From: Andy Mitton
To: [PRC](#)
Subject: SAAM public input DCI# 3024753
Date: Thursday, December 01, 2016 8:02:23 AM
Attachments: [FSOP-LPB SAAM-VP 2016-10-04 final.pdf](#)
[2016-06-23 Landmarks Board - SAAM Expansion.pdf](#)

RE: Seattle Asian Art Museum in Volunteer Park

FSOP-Landmarks Board – Seattle Asian Art Museum in Volunteer Park - Comments

– Current park plan

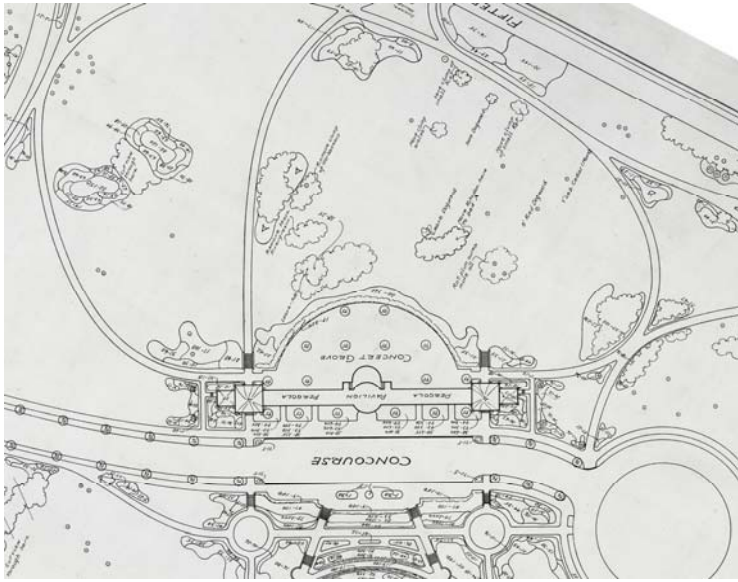
- A. In the lawn in the front (west side) of the museum, the landscape architect proposes to install a new ADA path through the north Hoggson lawn and to reconfigure the existing one in the south lawn to be compliant. We support making the south path compliant, but do not think that inserting a path in the north lawn is appropriate, since it was not part of the Hoggson plan. Inserting intrusions just for the sake of creating symmetry does not meet the intent of Federal Standards. The path on the south side requires less grade change and thus can sit more discreetly in the landscape.

- B. The existing path that connects the north lawn of the museum to the northeast park greensward, is an important connector within the park and provides a typical Olmstedian experience of transitioning between spaces and being able to see through and be drawn to the next space. The upper section of this path is part of the Hoggson plan, which reconnected the original east-west Olmsted path when the museum was built in 1932.

The museum proposal takes over this path as access to the elevated ADA ramp for staff. We believe that both needs can be met, by having the path divide to join the ramp and allow the park path to continue down into the park. Retaining this path is highly desirable.

- C. Reestablishing the east-west Olmsted path is important for continuing access from the east side of the park to the heart of the park in front of the museum. The Hoggson plan was laid out to retain this important east-west connection, but over the years it has, in effect, been blocked by parking and dumpsters.

There is an opportunity to reinstate this historic connection, not as a main ADA path, but as an optional path connection so that park users have a convenient and direct way to get from the east side of the park to the front of the museum. The dumpsters are proposed to be placed out-of-sight behind the loading dock and there is no need for a parking lot to

- D. The proposed ADA connection north of the museum in the northeast greensward by itself takes park users far out of their way, but in combination with the existing and reinstated path connections described above (B. and C.), it could potentially provide an acceptable ADA route if the grading and landscape impacts are properly addressed in laying out the path. Further analysis of circulation routes in the park needs to be done before implementing this new path connection (see E. below).
- E. Resolving ADA access from the SE corner of the park, where the bus stops are that serve the park and museum, needs more attention. Improving such access and determining how it should go through the park is a critical need in addressing pedestrian and wheelchair access.

1909 Olmsted Planting Plan overlaid with 1932 Hoggson Plan and main floor plan of Seattle Asian Art Museum with proposed expansion

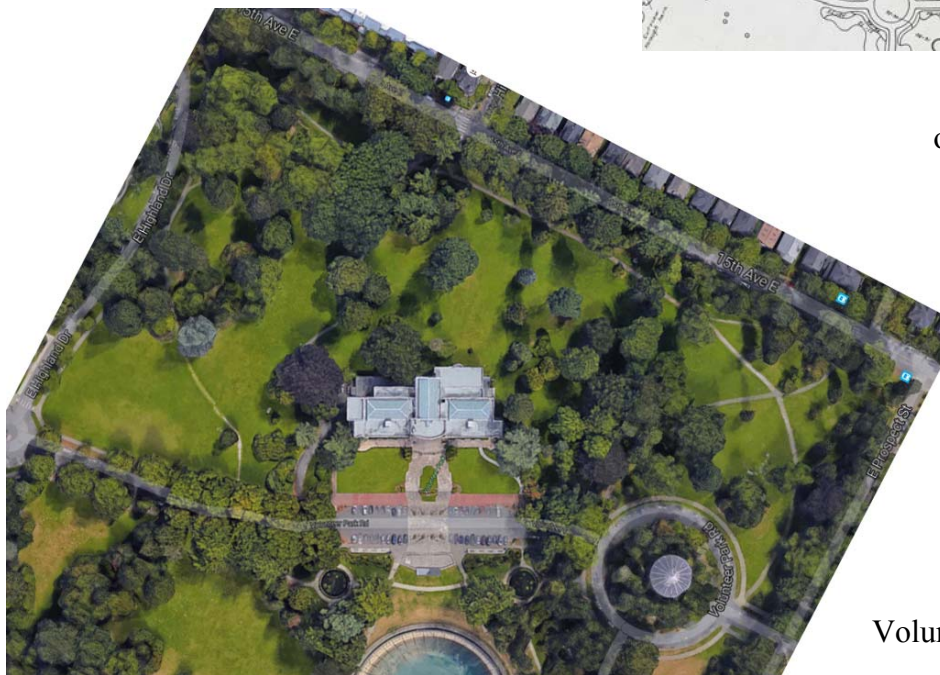
The Olmsted Plan provides the framework of circulation within the park. The museum proposal has significant impacts on that circulation system. As one of the first goals in rehabilitation is to strengthen the historic character, including the historic circulation patterns, we believe that there are better solutions that meet the ADA access needs while retaining and reinstating some of the original path connections.
